IFB No. **24-32 Administration Building 4th Floor Renovation**

RE: **ADDENDUM NO. 3**

RE: ADDENDUM #3

PROJECT: RPS 205 ADMINISTRATION BUILDING
4th FLOOR RENOVATION
ROCKFORD, ILLINOIS

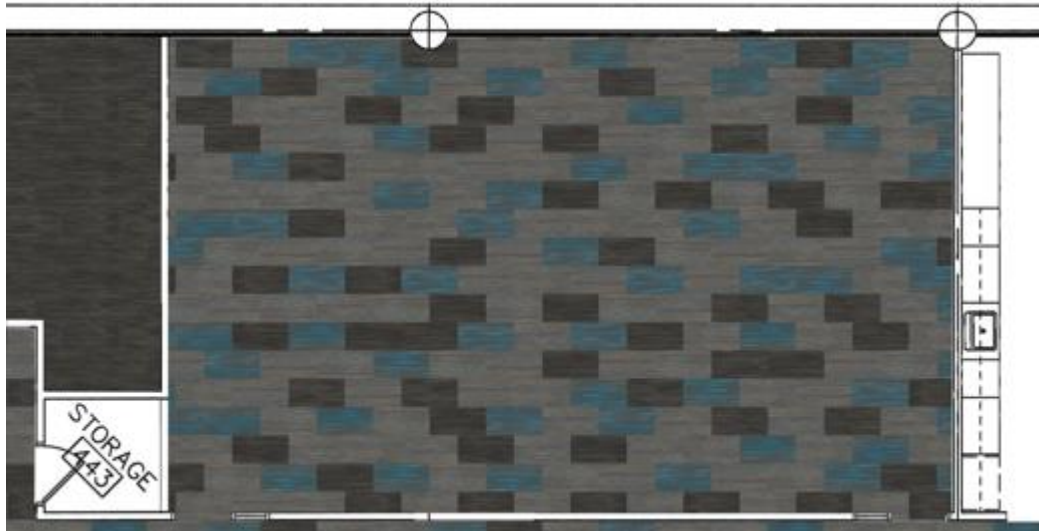
- A. CPTT1 is correct as Shaw Analog Filter.
- B. See attached image for example of CPTT1, 2, & 3 pattern distribution in areas designated on A2.1 & I1.1. This image is to be used as a reference for areas indicated by Floor Pattern Key.
- C. Carpet tiles shall be centered in hallways where pattern is parallel. See arrows on I1.1 plan for carpet tile orientation.
